From: caden1206@hotmail.com
To: [PUBCOMMENT-OCC](#)
Subject: Public comment on Permit Number 164838
Date: Sunday, February 13, 2022 4:57:03 PM
Attachments: [Gunter Concrete Batch Plant Cluster Modeling Report \(1\).pdf](#)

PERMIT NUMBER: 164838

DOCKET NUMBER: 2022-0092-AIR

**AIR QUALITY DISPERSION MODELING REPORT
CONCRETE BATCH PLANT CLUSTER – GUNTER, TX**

Figure 3
Wall Street Road Concrete Batch Plant Cluster
H2H 24-hour PM₁₀ Concentrations (μg/m³)

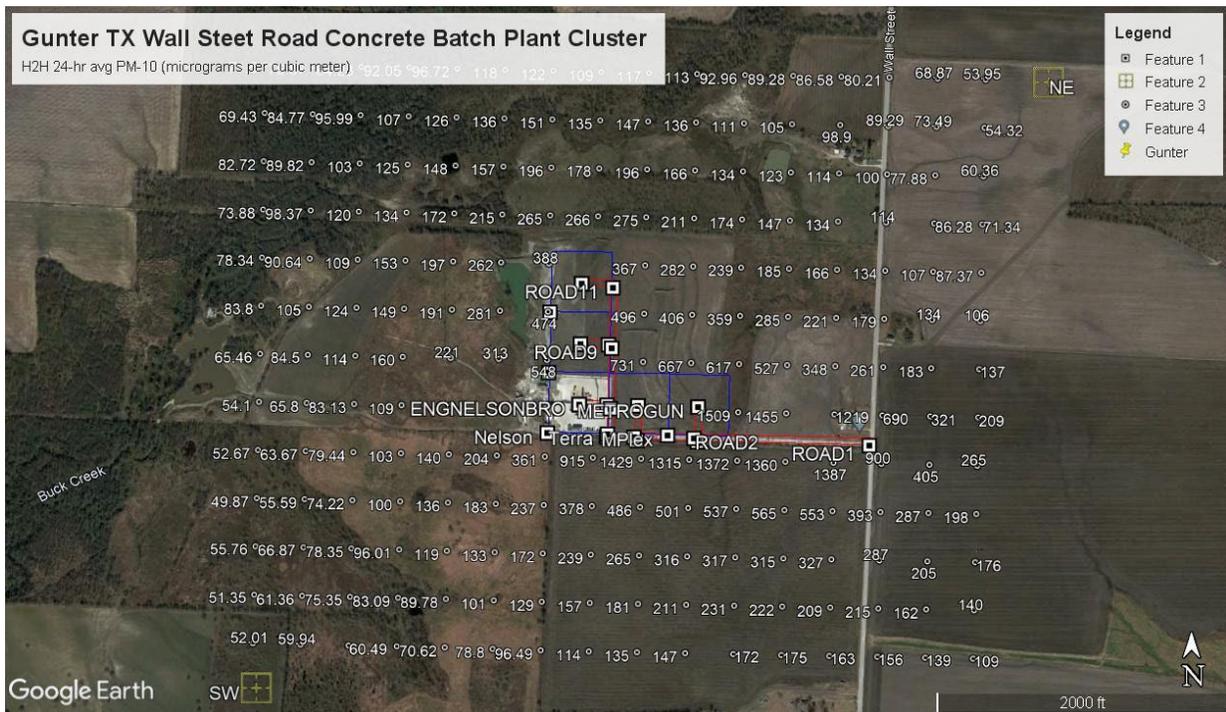
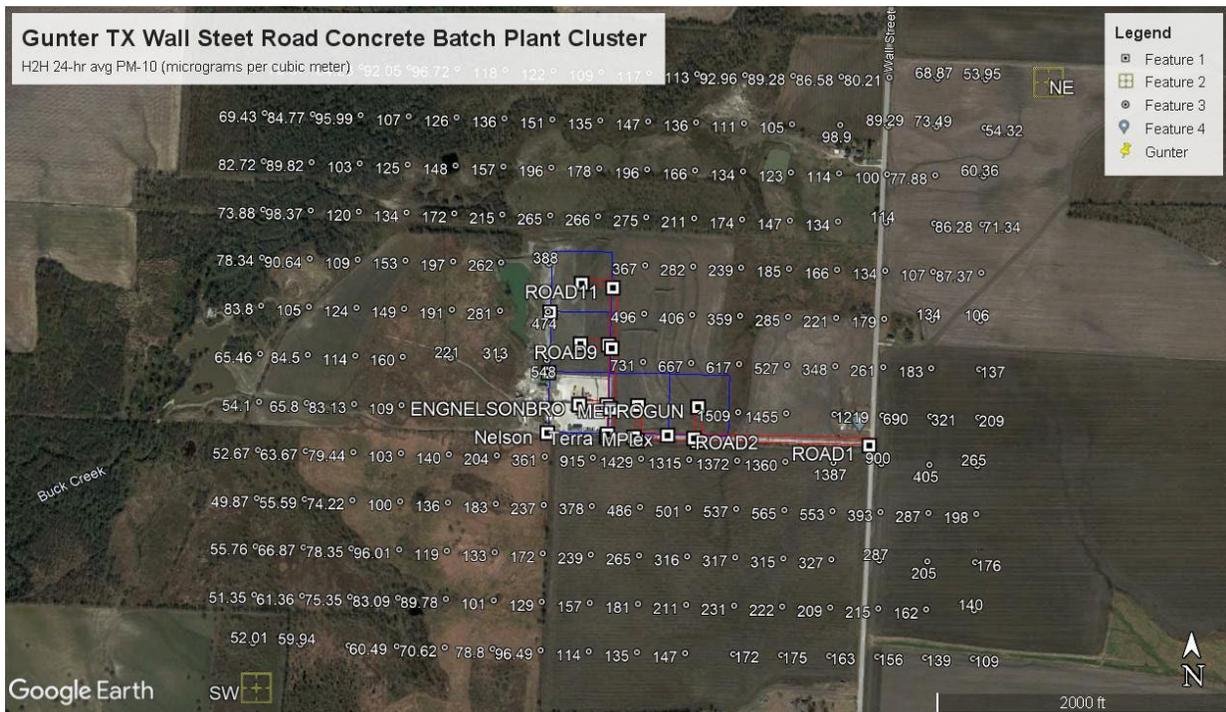
Dispersion modeling predicted that the H2H 24-hour average PM₁₀ concentration would be 1509.4 μg/m³. For comparison, PM₁₀ NAAQS for the 24-hour averaging period is 150 μg/m³. The geographic distribution of PM₁₀ concentrations overlaid on Google Earth has been provided in Figure 3. The figure shows the modeled H2H 24-hour average PM₁₀ concentration plotted at each receptor. Readers with an electronic copy of the document may zoom in on the image to provide greater clarity.

The modeling predicted that both the PM_{10} and $PM_{2.5}$ NAAQS in the vicinity of the concrete batch plant cluster would be exceeded by a very wide margin. The modeled PM_{10} concentration exceeded the NAAQS by about a factor of 10 and the modeled $PM_{2.5}$ concentration exceeds the NAAQS by about a factor of 3 to 4. The modeling results also suggested that the fugitive dust from truck traffic along the access road from Wall Street Road would be the primary cause of the predicted NAAQS violations.

Figure 4
Wall Street Road Concrete Batch Plant Cluster
H8H 24-hour PM_{10} Concentrations ($\mu\text{g}/\text{m}^3$)

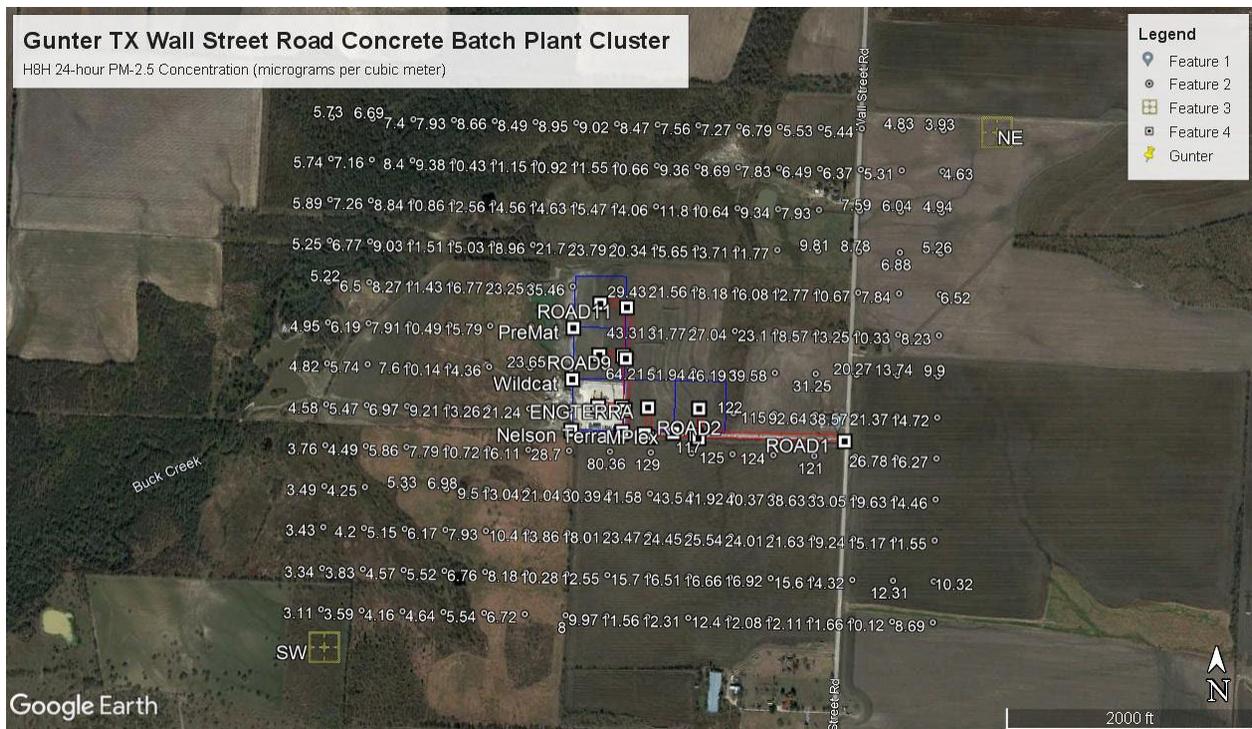
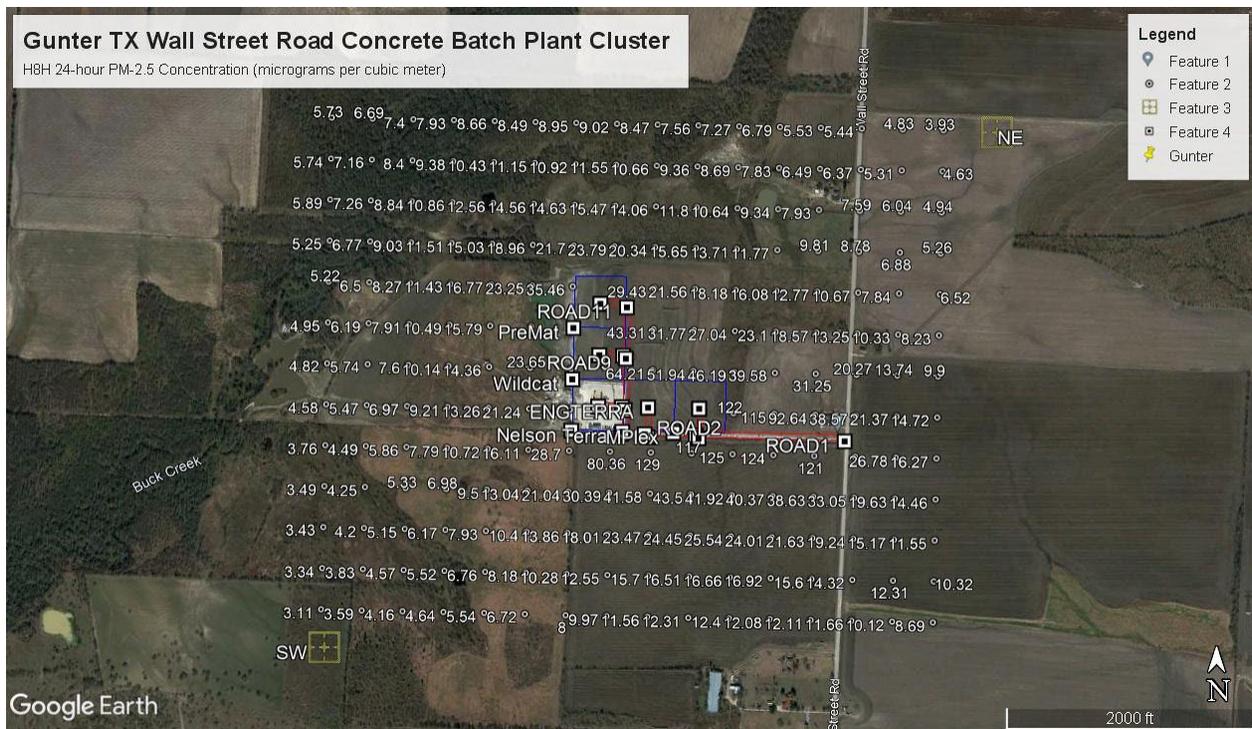
Dispersion modeling predicted that the H8H 24-hour average $PM_{2.5}$ concentration would be $129.4 \mu\text{g}/\text{m}^3$. For comparison, $PM_{2.5}$ NAAQS for the 24-hour averaging period is $35 \mu\text{g}/\text{m}^3$. The geographic distribution of $PM_{2.5}$ concentrations overlaid on Google Earth has been provided in Figure 4. The figure shows the modeled H8H $PM_{2.5}$ 24-hour average concentration plotted at each receptor. Readers with an electronic copy of the document may zoom in on the image to provide greater clarity.

Figure 5
Wall Street Road Concrete Batch Plant Cluster
H8H 1-hour NO₂ Concentrations (µg/m³)

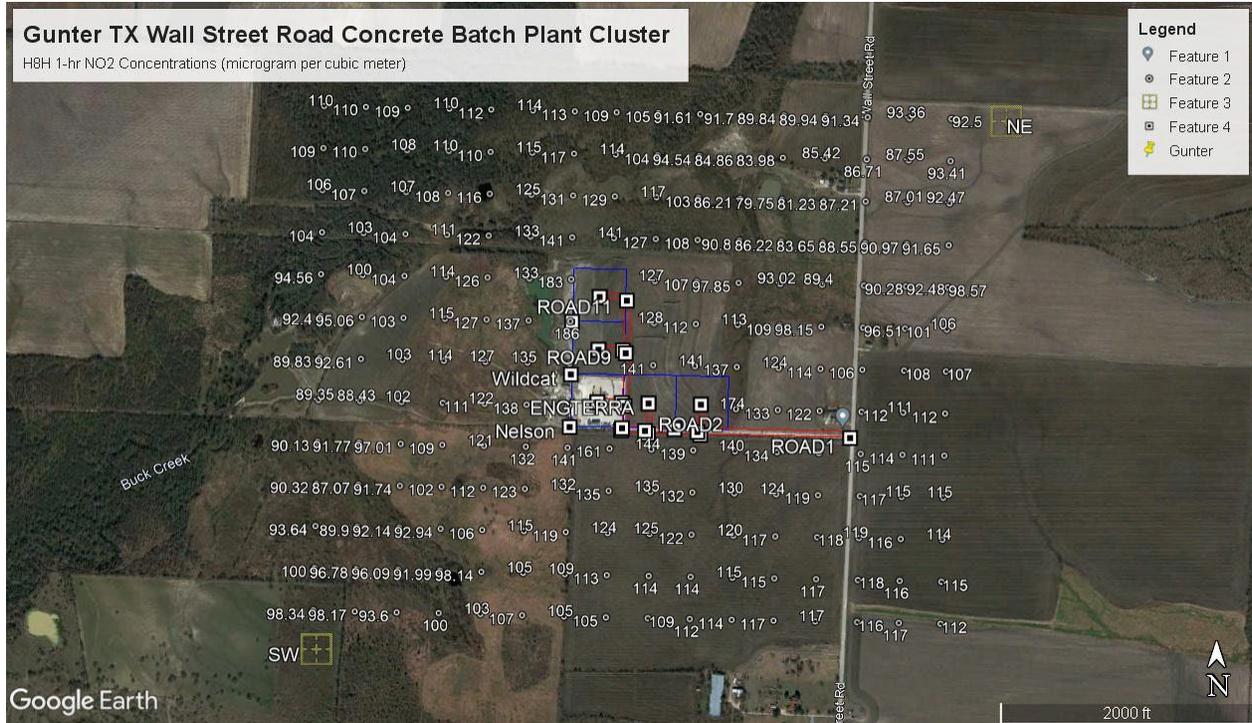
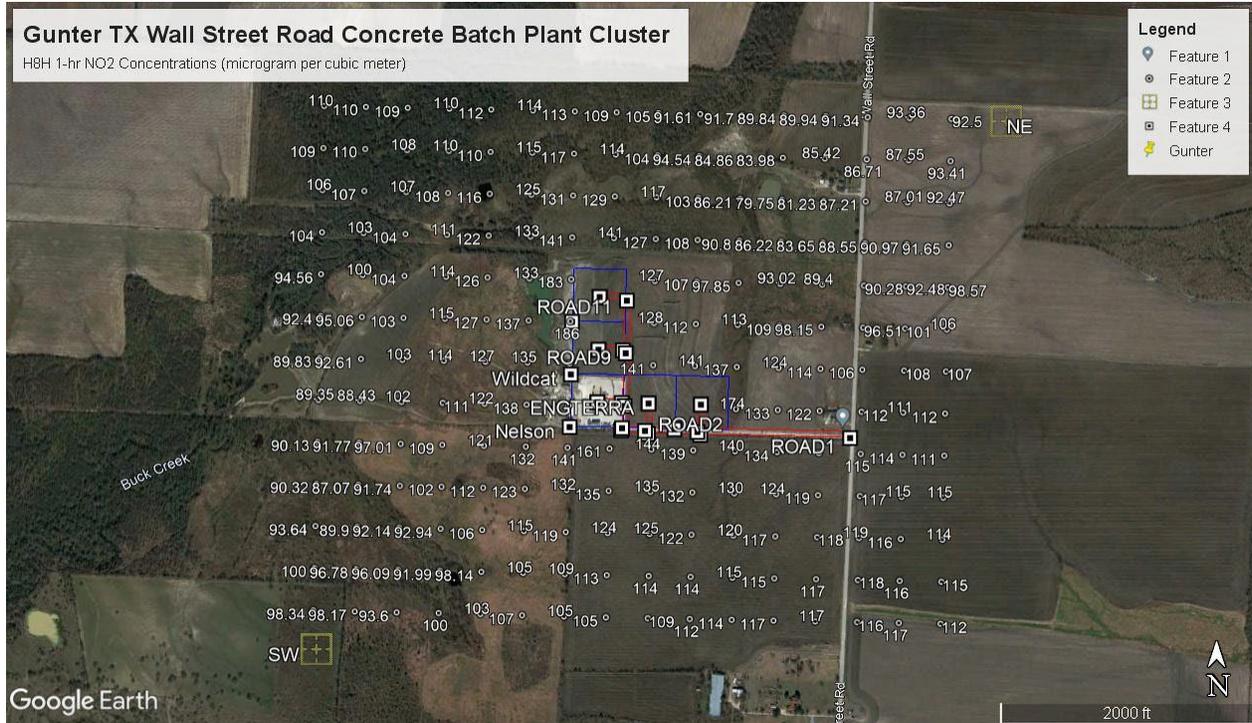
Dispersion modeling predicted that the H8H 1-hour average NO₂ concentration would be 208.4 $\mu\text{g}/\text{m}^3$. For comparison, NO₂ NAAQS for the 1-hour averaging period is 188 $\mu\text{g}/\text{m}^3$. The geographic distribution of NO₂ concentrations overlaid on Google Earth is provided in Figure 5. The figure shows the modeled H8H NO₂ 1-hour average concentration plotted at each receptor. Readers with an electronic copy of the document may zoom in on the image to provide greater clarity.

The modeling results indicated exceedances of the applicable National Ambient Air Quality Standards (NAAQS) for all pollutants (PM₁₀, PM_{2.5} and NO₂). Therefore, the dispersion modeling study concludes that the Texas Air Quality Standard Permit for Concrete Batch Plants (Effective Date September 22, 2021) is not protective of the NAAQS when multiple concrete batch plants are located in close proximity to one another.

Figure 2
AERMOD Source Input Locations

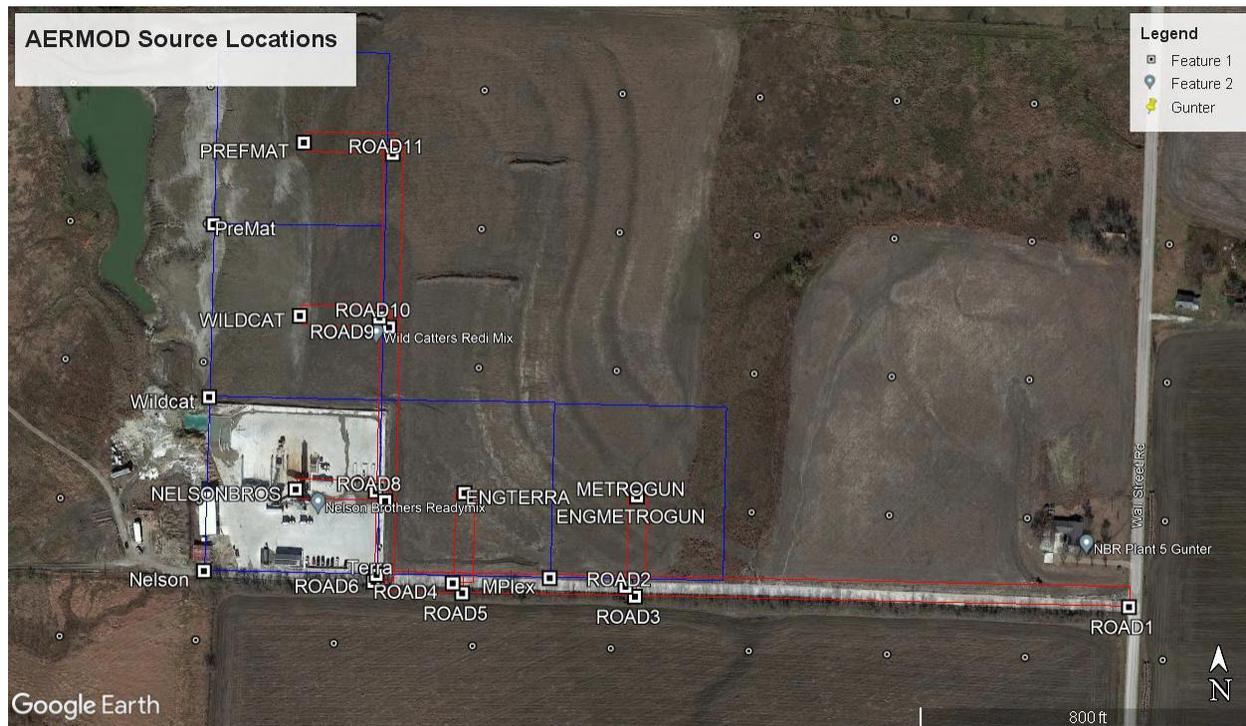
For the AERMOD modeling, truck traffic fugitive dust emissions were assigned to one of eleven (11) road segments. The road segments and other source locations are illustrated in Figure 2. Road segment #1 is the entry/exit at Wall Street Road and the segments are numbered sequentially as one moves east and north from the Wall Street Road entry/exit point. The assumed access roads for each individual concrete batch plant were assumed to intersect the common access road at the southeast corner of each individual batch plant property and were aligned north/south just outside the east boundary of each individual facility. At the midpoint of the eastern boundary for each facility, the truck traffic was assumed to turn 90 degrees to enter each facility. The internal roads within each facility were assumed to run from this point to the truck loading station at the center of each facility. The details for the truck traffic fugitive dust calculations for each road segment are provided in the calculation spreadsheet (See Attachment 1).

Based on the Standard Permit, fugitive dust controls are required to mitigate dust generated from vehicle traffic. A control factor of 75% was applied to account for fugitive dust mitigation on road segments internal to each plant site. However, because the Standard Permit requires fugitive dust mitigation only within the identified batch plant boundary, no dust mitigation was assumed for road segments outside of the plant properties, such as the common access road.
